NVIC 4-85
29 May 1985

NAVIGATION AND VESSEL INSPECTION CIRCULAR NO. 4-85, CHANGES 1 & 2 INCLUDED

Subj: Recalls and Other Corrective Measures for Lifesaving Equipment

FITZ-WRIGHT SUITS RECALL PROCESS

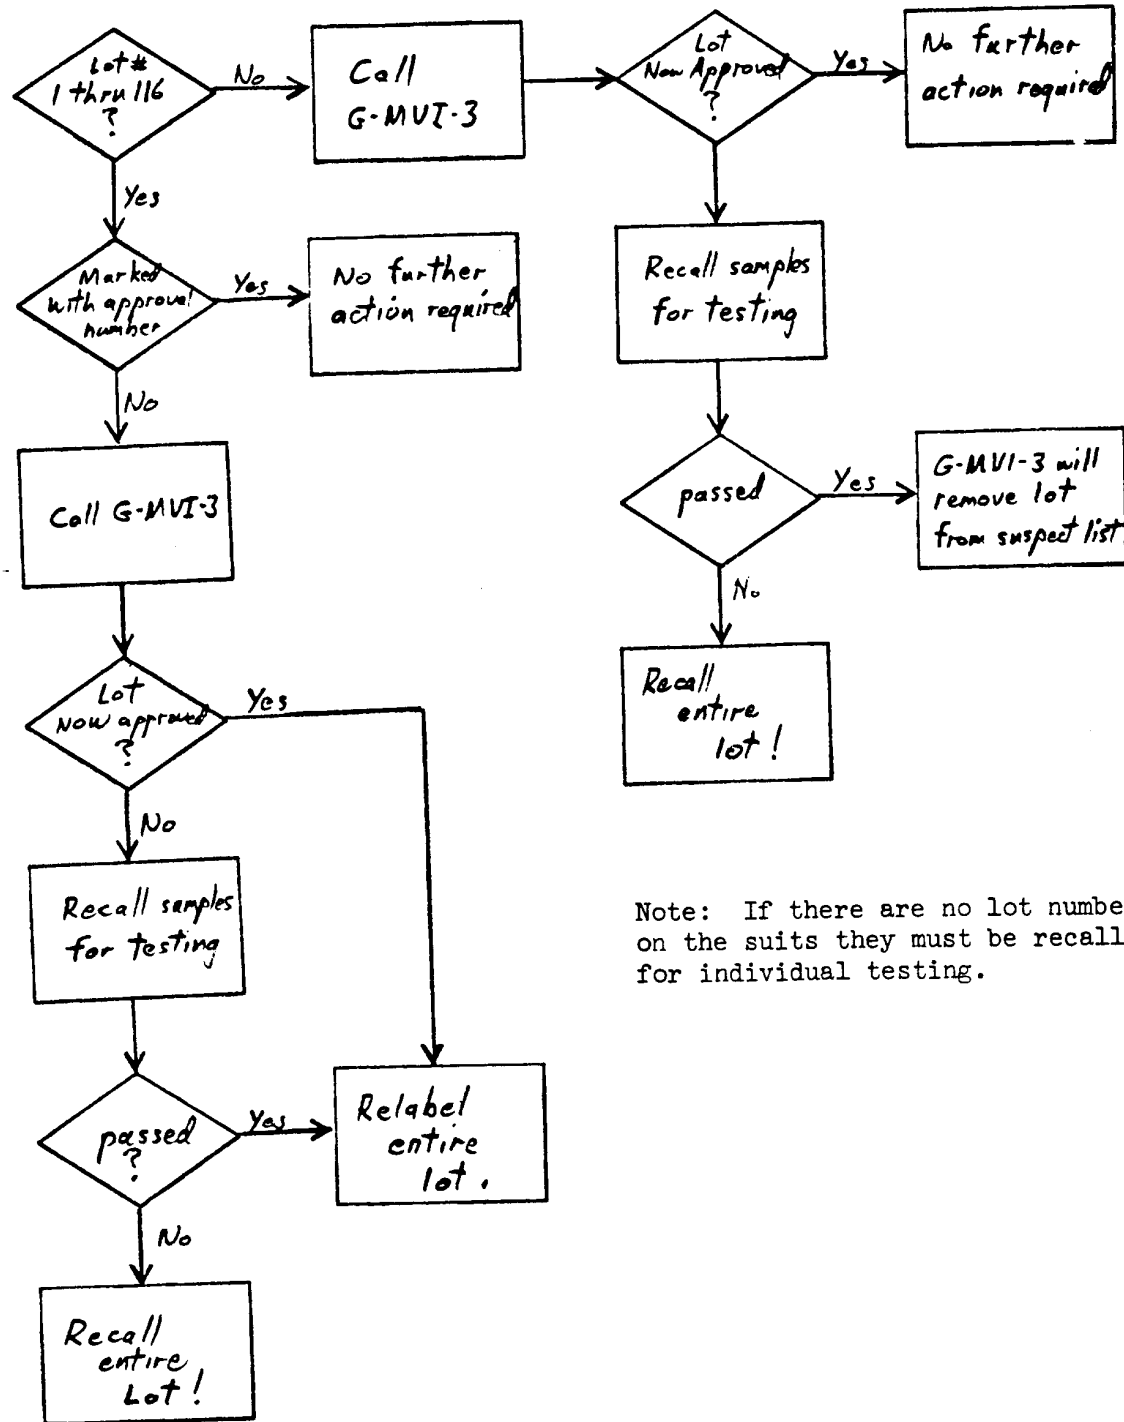
- a. Fitz-wright exposure suits up to and including Lot 116 were inspected and tested for Coast Guard approval by Warnock Hersey professional Services but were not marked with an approval number on the suit.
- b. Production inspection has since been taken over by Underwriters Laboratories (UL), but suits from lot numbers 117-132, 134, and 136-137 may have been labeled as Coast Guard approved even though they were not inspected and tested at the factory by Warnock Hersey or UL.
- c. Some Fitz-Wright suits have been found to have no lot numbers, and their factory inspection status can not be determined.

- a. Where records in the custody of Underwriters Laboratories indicate that a lot numbered 116 or lower was inspected by Warnock Hersey professional Services, the suits may be relabeled in the presence of a UL inspector.
- b. Where the records indicate that any lot was not inspected by an independent laboratory, representative samples of the lot must be returned to Fitz-Wright for testing by a UL inspector. Fitz-Wright will provide replacements for the samples recalled for testing. After samples of a lot have been tested and inspected, the lot will be approved and all suits of that lot may be relabeled in the presence of a UL inspector.
- c. Any suit which does not bear a lot number can not be considered Coast Guard approved.

- a. Coast Guard inspectors should contact Commandant (G-MVI-3) when suspect suits are encountered, giving lot number of suits, approval number if marked, and identity of vessel and operator. Vessel need not be detained. Commandant (G-MVI-3) can be reached on FTS 426-1444.
- b. Operators may contact Underwriters laboratories to determine the status of suspect suits and arrange for relabeling. If samples from the lot are needed, the operator will be referred to Fitz-Wright to arrange for replacements and shipping of samples. Point of Contact at UL is:

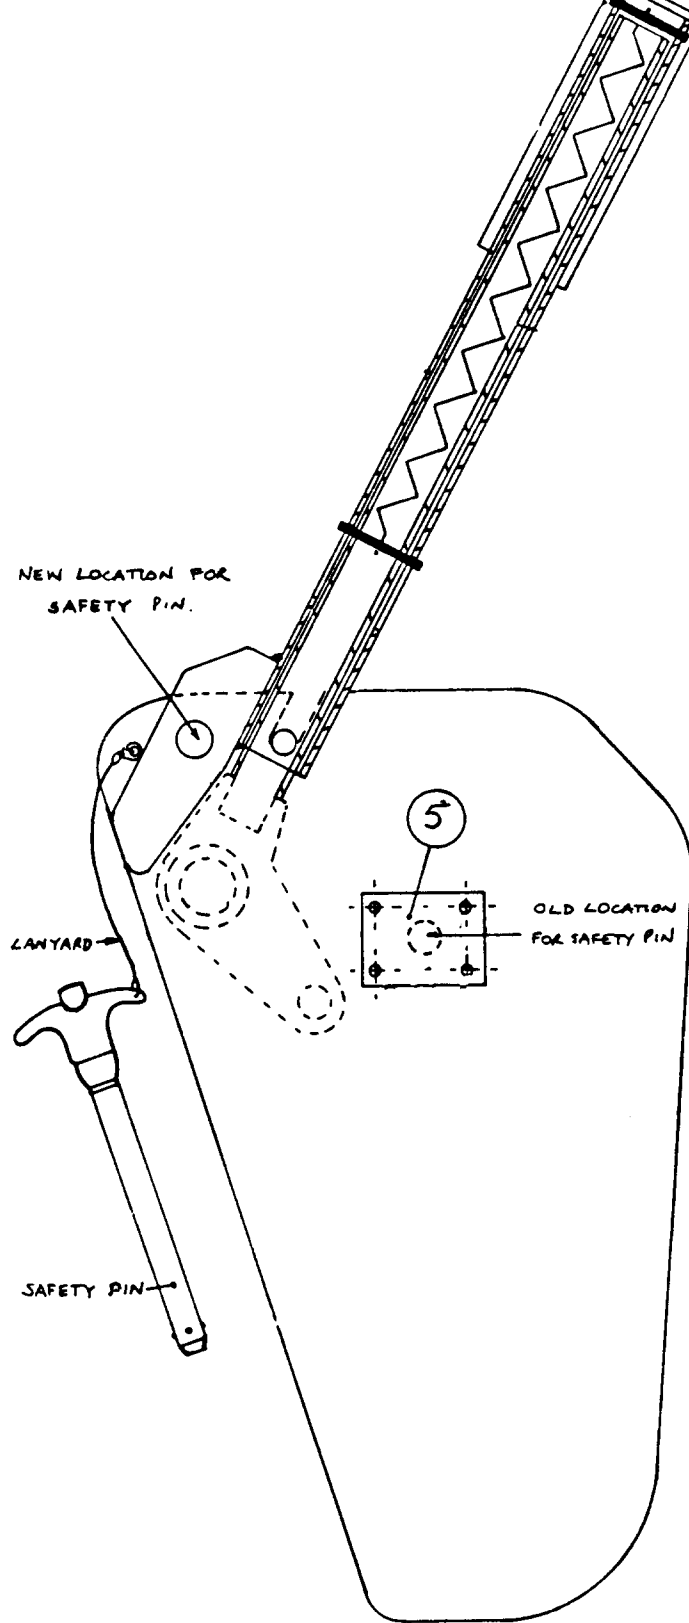
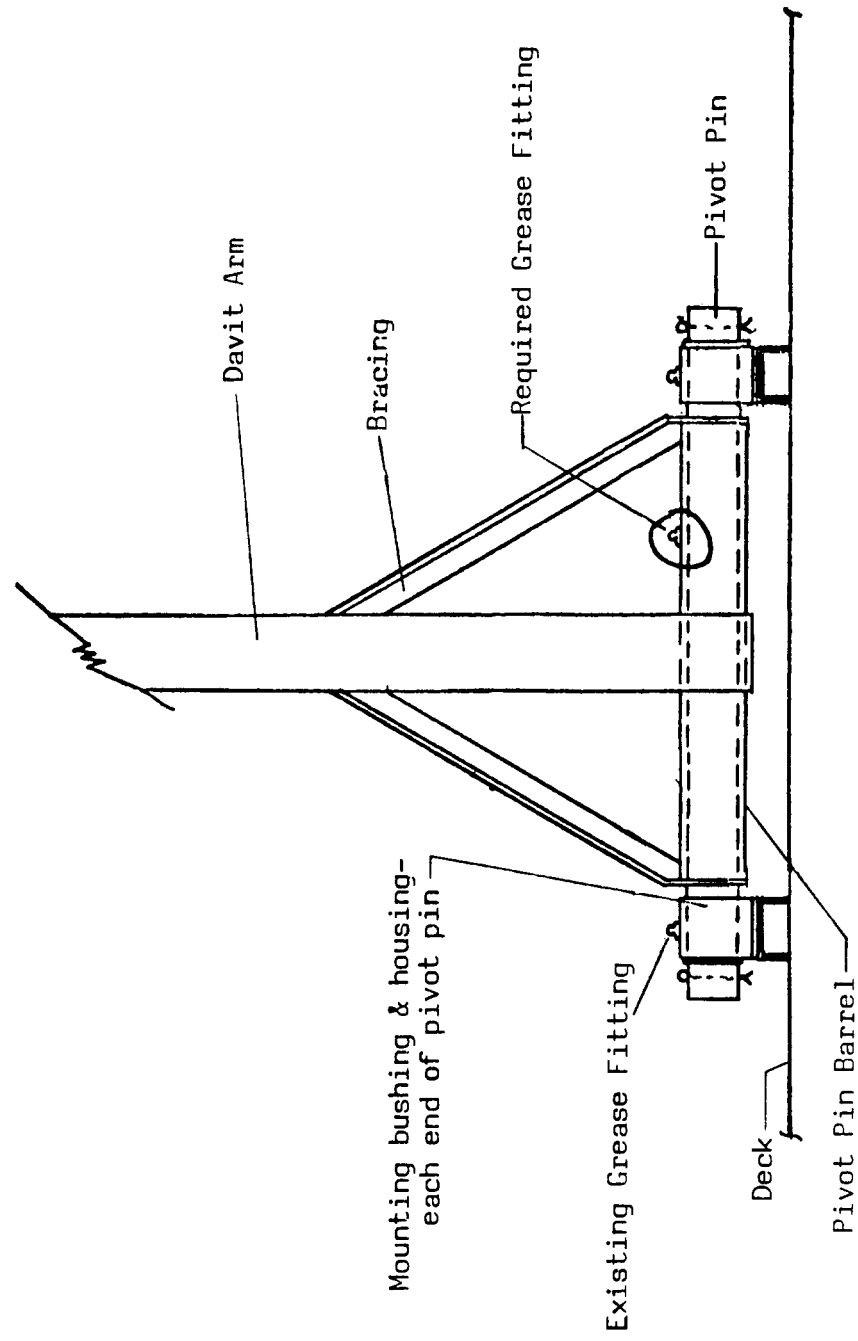
1. PROBLEM. The safety pin on the Titan release gear operating handle used in certain Watercraft America lifeboats, can be inserted before the handle is in the safe, fully closed position. In this condition, the release hooks may appear to be fully closed, but may unexpectedly open when a load is applied.

2. DISCUSSION. Watercraft America, Inc. has developed a modification to prevent the accidental insertion of the safety pin before the handle is in the fully closed position.

- a. Titan release gear with approval number 160.033/69/0 must be modified. Titan gear that has been modified can be identified by the cover plate over the old safety pin hole (item 5 on the drawing on the following page), and by the plate added to the release gear handle to accommodate the new safety pin location (see "NEW LOCATION FOR SAFETY PIN" on the drawing).

3. ACTION.
 - a. Vessel and MODU operators having Watercraft America lifeboats equipped with Titan gear having approval number 160.033/69/0 shall make sure the release gear is modified in accordance with Watercraft America drawing SP-201 and Engineering Instruction P-131, both dated 28 October 1985. The Coast Guard Officer in Charge of Marine Inspection shall be notified before the modification work begins. The drawing and instruction may be obtained from:

**ILLUSTRATION 1**

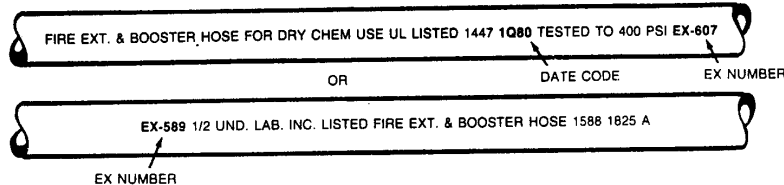
1. If extinguisher has a yellow "Inspected" sticker on the front, go to step 9.
2. Find U.L. Listing information printed on hose (either white print or molded on hose cover). (See illustration 1 below.)

3. If there is no printing, or printing is unreadable, replace hose assembly and destroy old hose.
4. Refer to **EX** number on hose, if it is **NOT** EX-607 or EX-589, hose is good, do **NOT** replace.
5. If EX-607
 ↓
EX-607
 6. If EX-607, refer to date code (Example 1Q80 means 1st Quarter 1980)
 7. If Date Code is between 1Q77 and 4Q83, replace hose assembly, destroy old hose. If dated **BEFORE** 1Q77, hose is good, go to step 9.
- OR If EX-589
 ↓
EX-589
 6. If unit is **NOT** Ansul Model 20 Hand Portable, hose assembly is good, go to step 9. (To identify unit, refer to maintenance nameplate on back of extinguisher.)

**ILLUSTRATION 3**

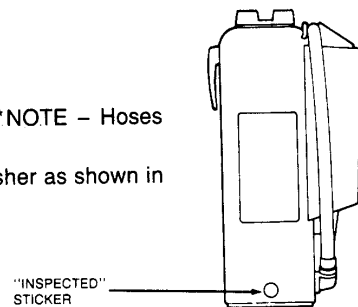
9. Perform recommended inspection and maintenance on **ALL** extinguishers. *NOTE - Hoses not included in this program may need replacement due to normal wear.
10. When all work is completed, place yellow "Inspected" sticker on extinguisher as shown in illustration 3.

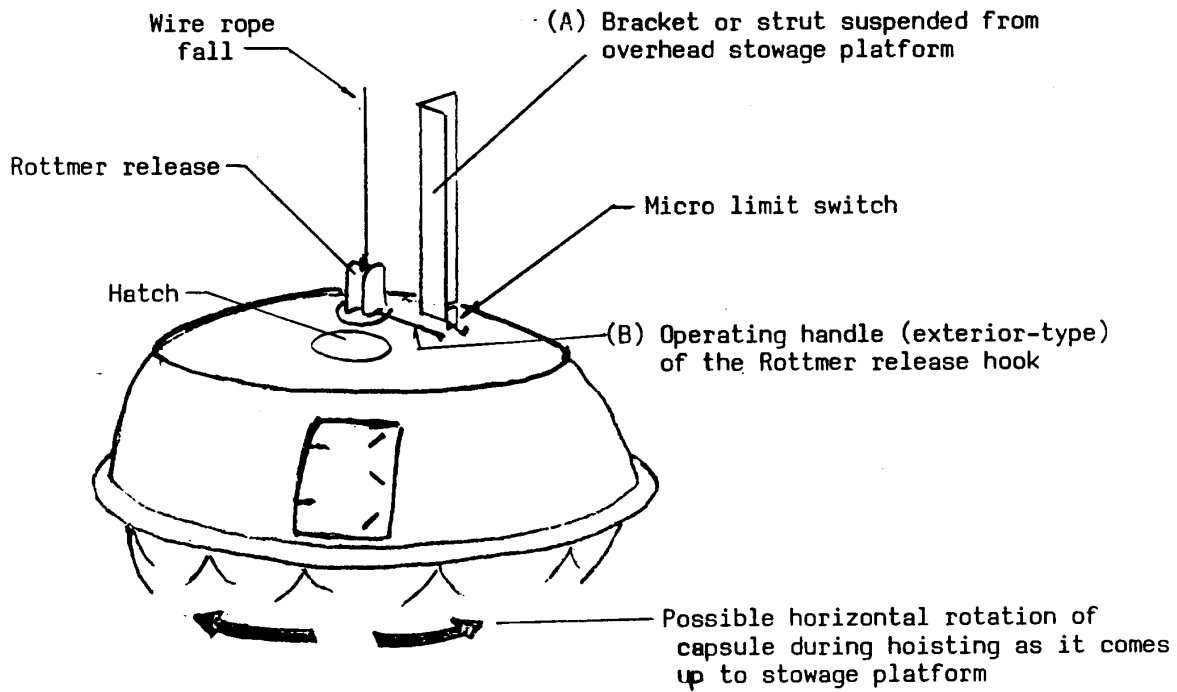
2. DISCUSSION: The unauthorized modifications may appear to be almost identical to the brackets that hold the limit switches which are part of the approved launching system. If brackets are added and not carefully located, they can engage the cable and sector operating mechanism on those capsules equipped with Rottmer type hooks. This has happened on two separate occasions, resulting in the accidental opening of the hook and dropping of the capsule. Any person on board the capsule is at risk of being seriously injured.

NOTE: The above arrangement has the danger of letting the operating handle(B) of the Rottmer release to push against the bracket(A) suspended from under the stowage platform. This could result from the horizontal rotation of the capsule as it comes up into the stowed position. This unintended interference is a potential hazard because of the chance that the operating handle(B) could be moved from its locked position, thus permitting the capsule to drop free of the wire rope fall.

3. ACTION: Servicing personnel and Coast Guard inspectors should make sure -that any brackets on Whittaker capsule launching devices are part of the approved system or are approved modifications. Generally, the only brackets coming close to the surface of the capsule should be those holding the limit switches which prevent the capsule from being winched into the stops under motor power. Any others should be considered suspect, unless the owner or operator can show that they are approved additions. Any unauthorized modifications of this type must be removed. Questions on whether or not such brackets are approved can be answered by the manufacturer:
